**RE:** **PD2024-00002 Sunrise Lakes (3804 Sunrise Blvd)**  
**PD Final Site Plan**

**STAFF REPORT**

**Summary:** This application is proposing a rezoning to a Final Planned Development (PD) of forty-eight (48) single-family residences on 11.54 acres (4.16 units per acre), at 3804 Sunrise Boulevard. The property is zoned R-1 (less than 4 units/acre) with a future land use of RL (6.5 units/Acre). The site was recently annexed into the City of Ft. Pierce. The site is bordered by single-family RS-3 zoning on the south and west. To the north is a cemetery and the east is a Florida Department of Transportation

**Proposed Site Plan**

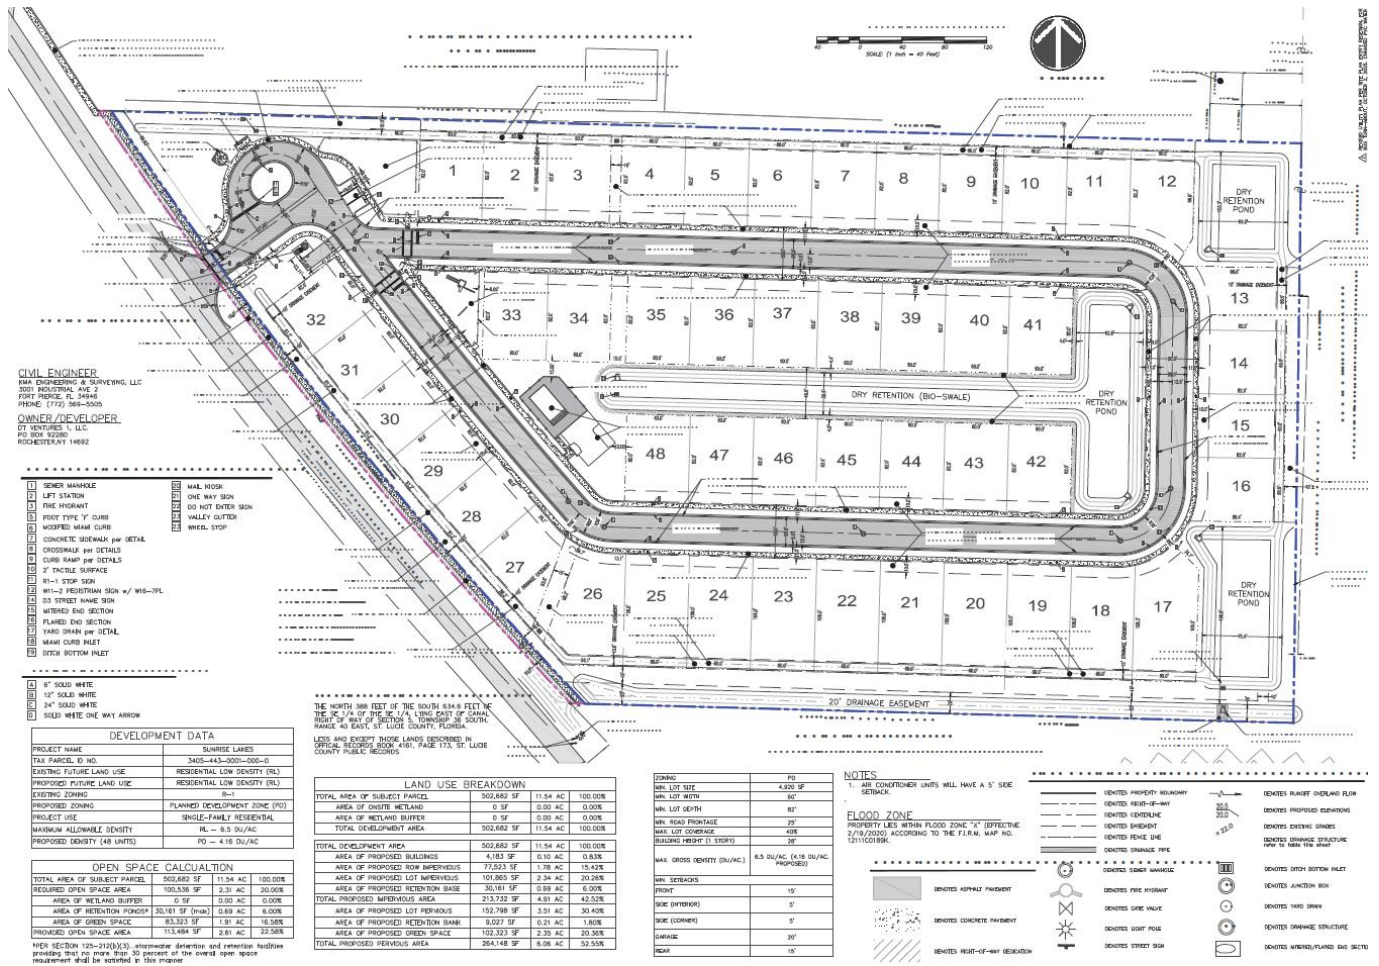
The present site plan incorporates the original Planning Board and School District recommendations for a school bus loop with improved turning radii.

1. All infrastructure, including the private lift station, force main along Sunrise Boulevard, school district sheltered bus stop, stormwater system, and sidewalk connecting the project to Bell Ave along Sunrise Boulevard, shall be completed prior to the issuance of first certificate of occupancy for a residential dwelling.

7. A masonry wall, minimum height of 6ft, shall be installed along the eastern property line as part of the landscape buffer to the industrial use, prior to issuance of first certificate of occupancy for a residential dwelling.

11. A revised final site plan, architectural elevations and landscaping plan shall be submitted for the proposed amenity center.
12. All applicable state or federal permits shall be obtained before commencement of the development.
